m. Carder
Industries, Inc.

THE “KICKER”

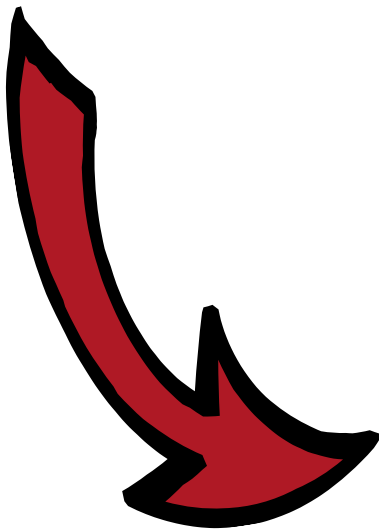
We have added a new feature to our NEW 5-Star nozzle. The indentation on the side of the clip provides a tab on inside of the clip. When the automatic shut off occurs, the lever swings down and contacts the tab on the clip and “KICKS” the clip out of the ratchet plate in the handguard.

This **ensures the clip will always release** when the automatic shut off occurs. The 5-Star clip is similar to the clip on the 11A and 7H type nozzles. Many of these do not release every time and may hold the main valve open, **which will let fuel continue to flow.**

In addition to 5-Star, the “KICKER” will work on the 11A, 7H and other models with this type of clip.
